HISTORIC AND DESIGN REVIEW COMMISSION

September 20, 2023

HDRC CASE NO: 2023-343
COMMON NAME: 958 E SOUTHCROSS
ADDRESS: 2900 ROOSEVELT AVE
2901 ROOSEVELT AVE
2835 ROOSEVELT AVE
1018 E SOUTHCROSS BLVD
992 E SOUTHCROSS BLVD
LEGAL DESCRIPTION: NCB 7674 BLK E LOT E PT & MID PT OF TR-1
NCB 7674 BLK C LOT W PT OF 1R & 2A EXC NE TRI 50 FT X 90 FT
NCB 7665 SE IRR 153.6 FT OF NE IRR 211.3 FT OF SW 503.6 FT OF 12
& N TRI 73.67 FT OF
NCB 7665 (ICP INDUSTRIES SUBD), LOT 39
NCB 8628 BLK LOT 3 (PICKUP INC SUBDIVISION)
NCB 7665 BLK LOT 16
ZONING: MXD, H, RIO-5
CITY COUNCIL DIST.: 3
DISTRICT: Mission Historic District
APPLICANT: Michael Clancy/Alamo Architects
OWNER: James Lifshutz/TEXAS HOME MORTGAGE INC
TYPE OF WORK: Construction of a mixed-use development with multiple structures, site and landscaping modifications
APPLICATION RECEIVED: August 18, 2023
60-DAY REVIEW: October 17, 2023
CASE MANAGER: Edward Hall
REQUEST:

San Jose Village

Restaurant Rehabilitation Scope

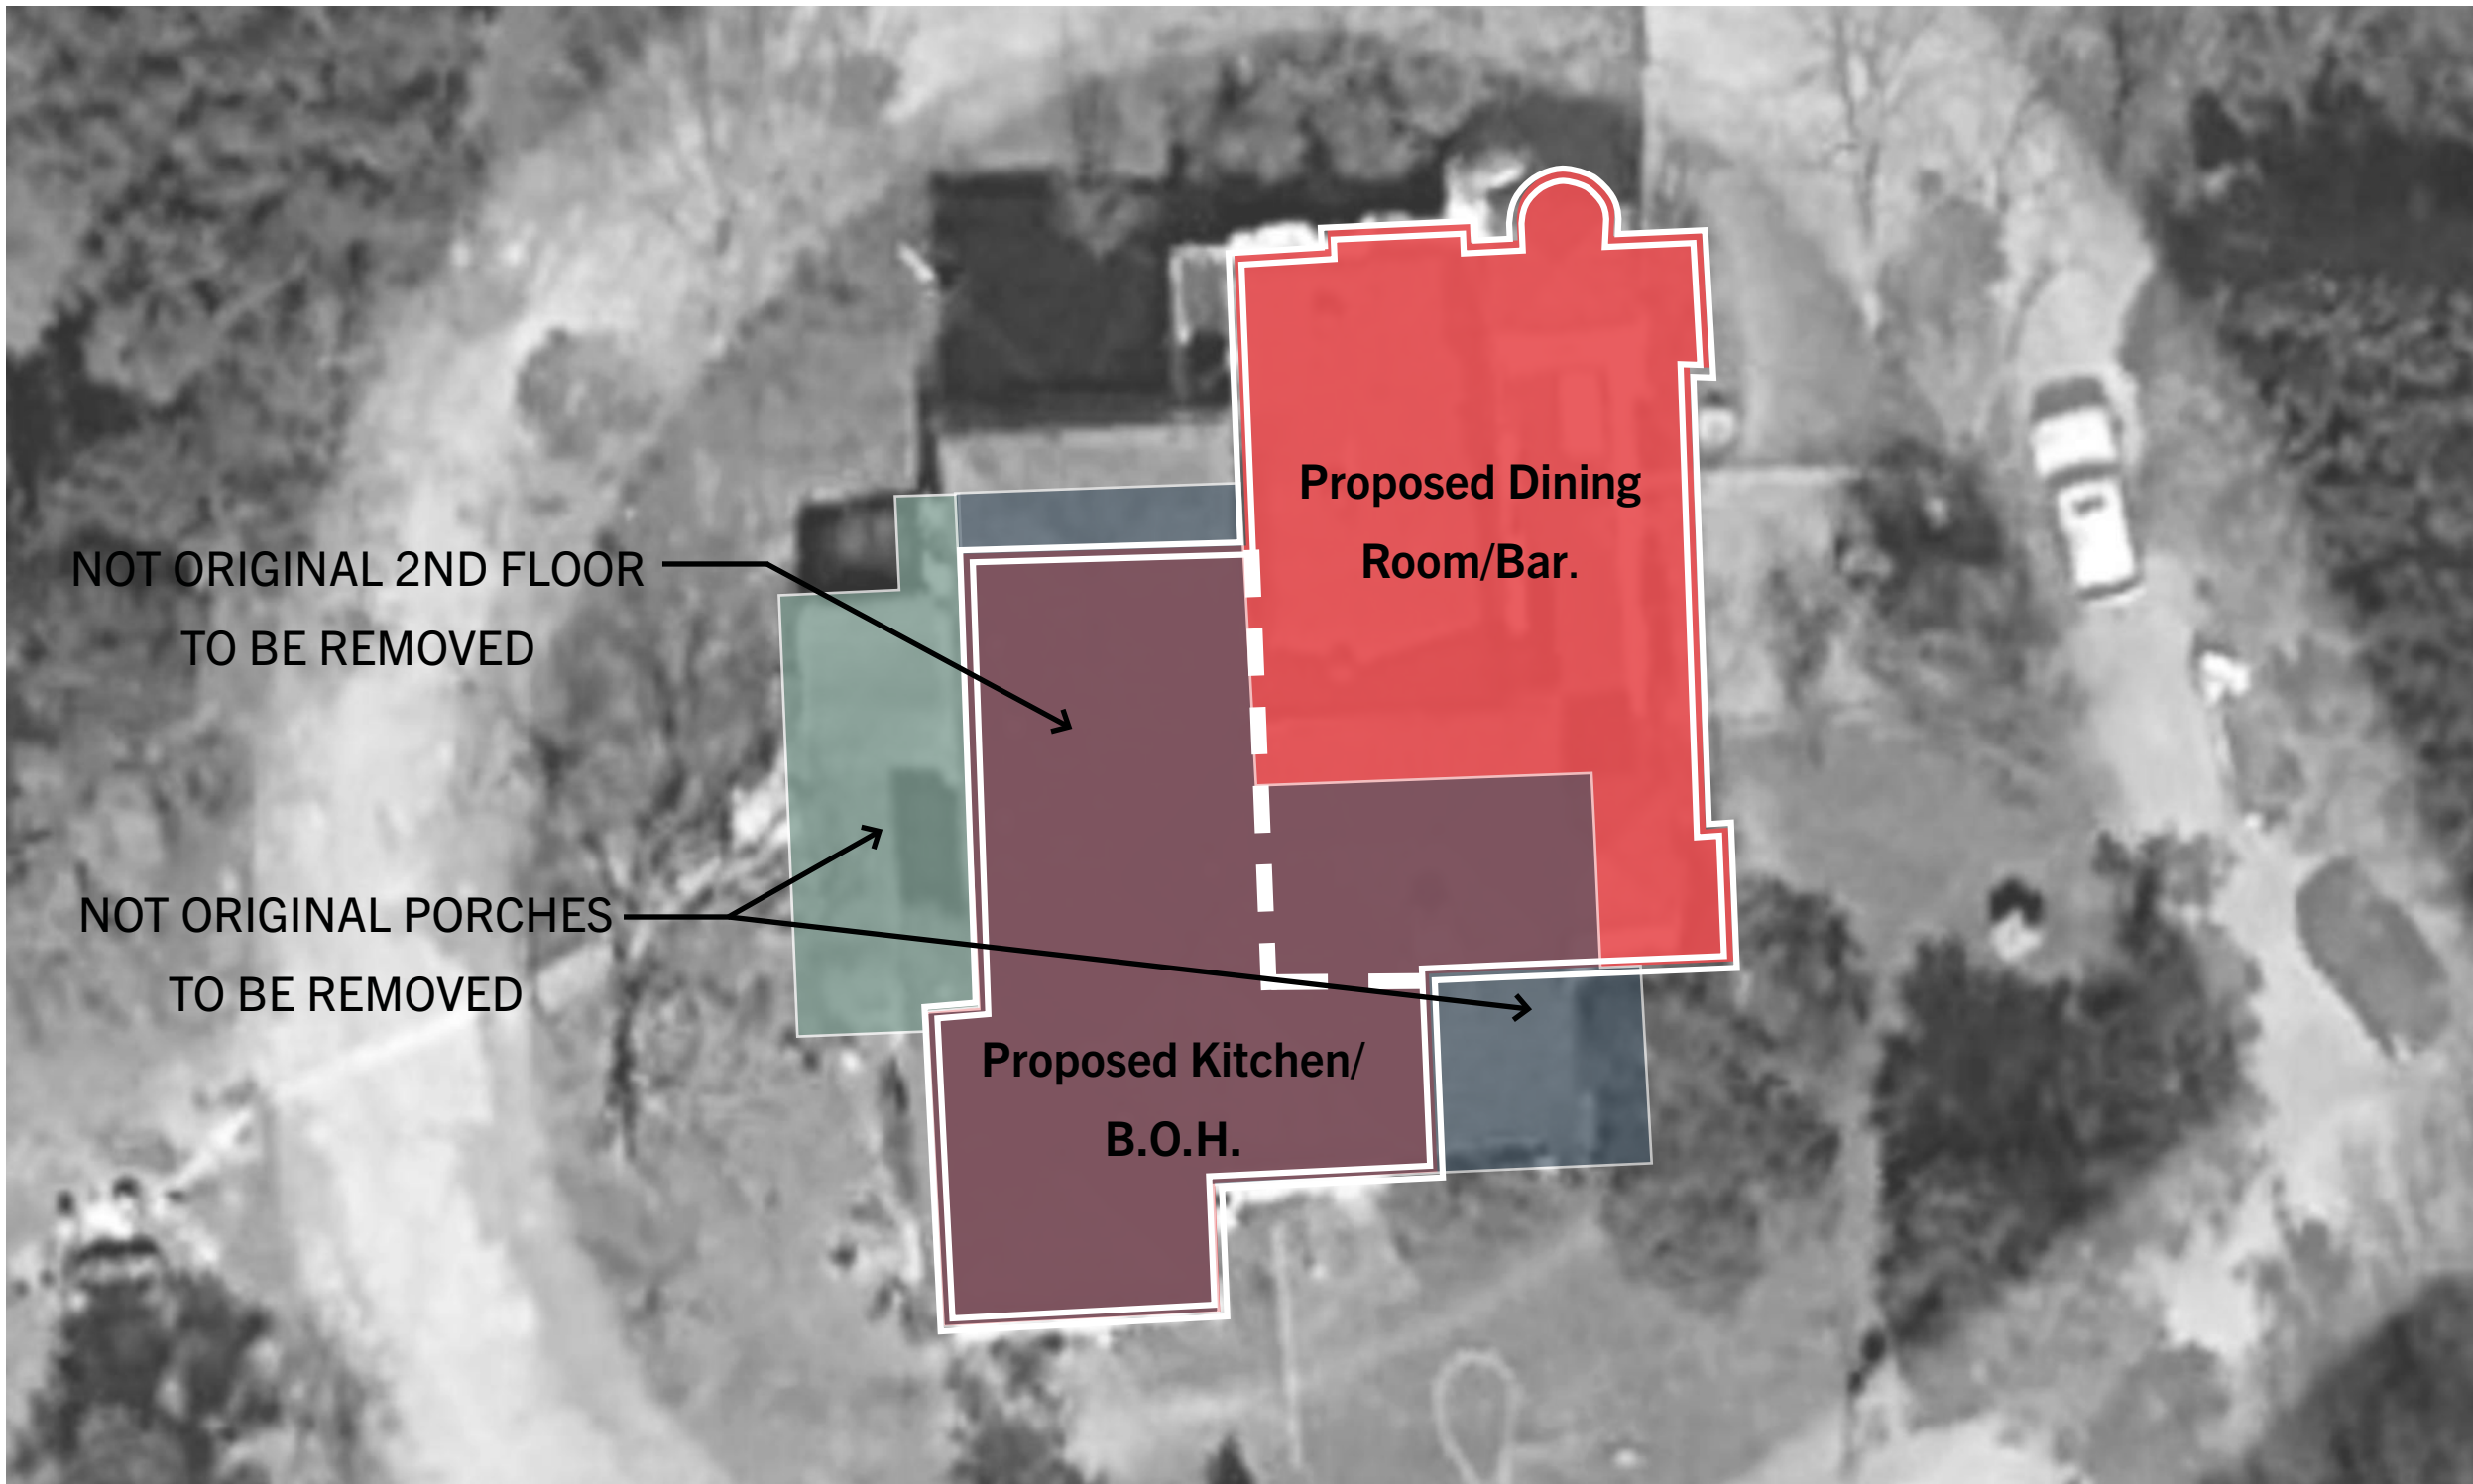
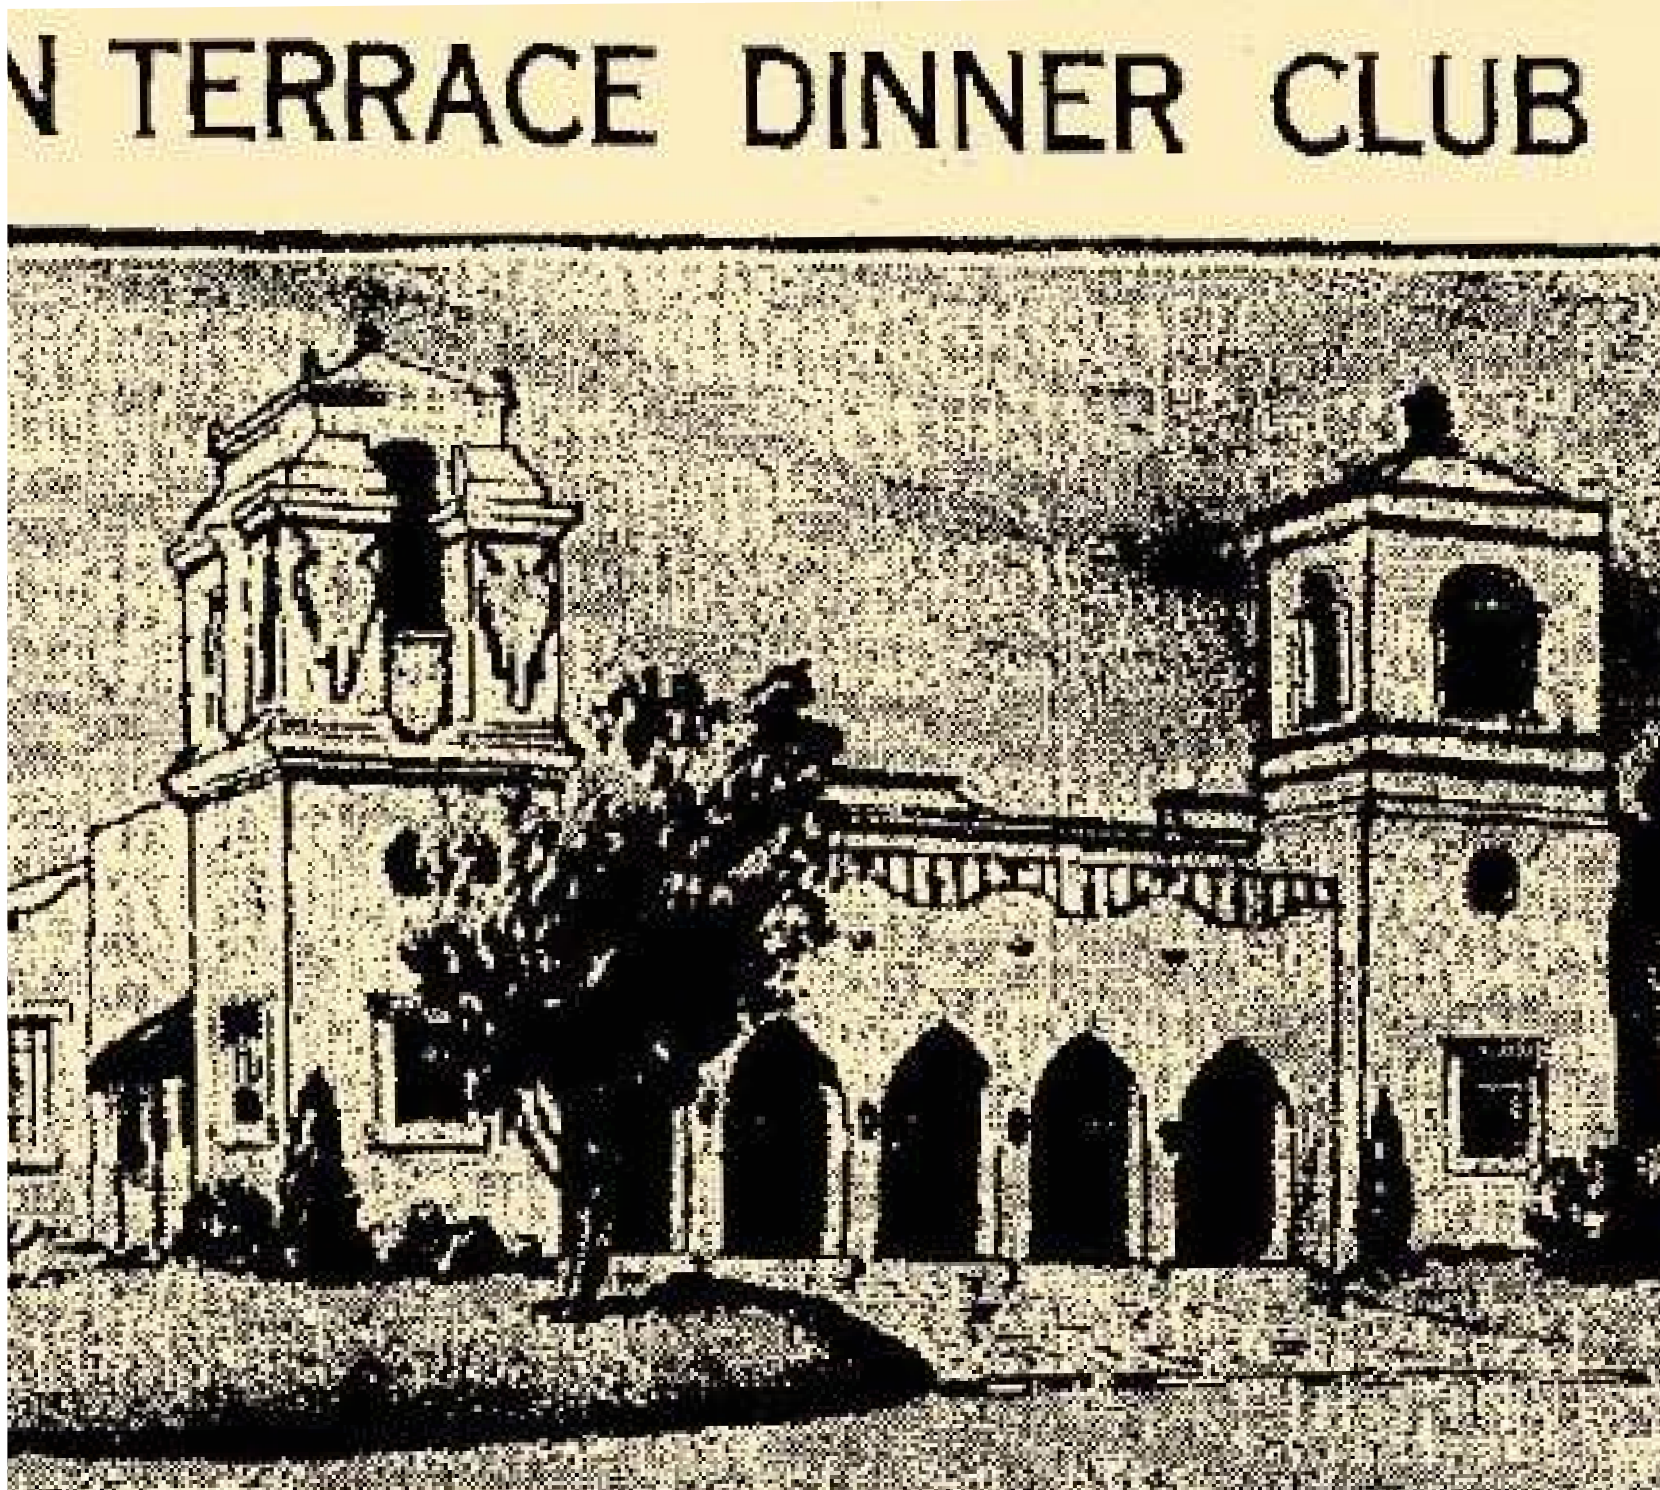
- d. **REHABILITATION** – The applicant has proposed to rehabilitate the historic structure located at 1901 Roosevelt Avenue. The historic structure was constructed circa 1935 in the Mission Revival style. The applicant has noted the removal of non-original additions that were constructed circa 1960 and 1980. Generally, staff finds the removal of additions that are not contributing to be appropriate. Staff finds that the proposed rehabilitation should be designed and performed in compliance with the Historic Design Guidelines.

- i. That a complete rehabilitation plan be submitted for review by the Historic and Design Review Commission that includes a complete construction document set. All scopes of rehabilitation should be consistent with the Guidelines for Exterior Maintenance and Alterations. Original materials, including windows, should be repaired. If original materials are deteriorated beyond repair, in-kind replacement should take place.
